April 26, 2010

**Re: Amended Additional Off-Site Soil Sampling – Western Grid
Cabot Carbon/Koppers Superfund Site
Gainesville, Florida**

Figure 1

Proposed Off-Site
Sample Locations to the West
Cabot Carbon/Koppers
Gainesville, Florida
Beazer East, Inc.
Pittsburgh, Pennsylvania

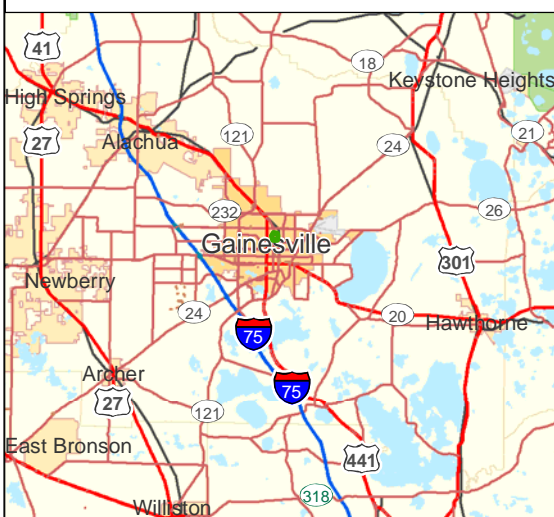
FDEP suggested adding 10 samples approximately 50 feet to the west of the western boundary of the Site, as FDEP believes that such samples may be helpful in refining the vertical delineation of dioxin/furans. As noted in the February 19, 2010 letter and also on **Figure 1** (attached), the proposed sampling plan calls for collection and standard 21-day analysis of five 0-6" and 6-24" samples approximately 100 feet west of the western boundary of the Site (shown as blue triangles on **Figure 1**). The purpose of these samples is to provide information on the vertical extent of dioxins and furans to the west of the Site. As indicated in the February 19, 2010 letter, based on the results of the initial five 6 – 24" samples, and in consultation with the US EPA, Beazer has already proposed to analyze up to 10 additional 6 – 24" samples to evaluate the vertical extent of dioxins. If dioxin/furan concentrations at the five 6-24" sample locations currently proposed do not exceed SCTLs, then additional 6-24" samples closer to the boundary of the Site may be collected. Such

FDEP observes that on-Site samples closest to the property boundary have TCDD-TEQ concentrations above the default residential SCTL of 7 parts per trillion (ppt), and requests three more samples along the southern quarter of the western property boundary. The southernmost sampling location proposed in the existing sampling plan paralleled one of the existing on-Site sampling locations so an additional off-Site sample at that location is not necessary. Two additional off-Site sampling locations have been added in response to FDEP's request. The first of the additional off-Site locations is 200 feet south of the most southerly previously proposed grid sample, and the second additional off-Site location is 400 feet south (**Figure 1**). At both of these off-Site locations, samples will be collected from both the 0 – 6" and the 6 – 24" depth interval. The 0 – 6" samples will be submitted for analysis with a standard 21-day turn-around time. Samples from the 6 – 24" depth interval will be submitted to the laboratory on hold.

ACEPD also requested that in cases where two grid samples are located along a property boundary common to two properties that an effort be made to not have two samples from the same property but instead, to have one sample collected from each of the two properties. Approximately 10 grid samples have been moved a few feet to accommodate this request (**Figure 1**).

additional sampling can be conducted as part of the predesign activities, if such sampling is determined to be necessary.
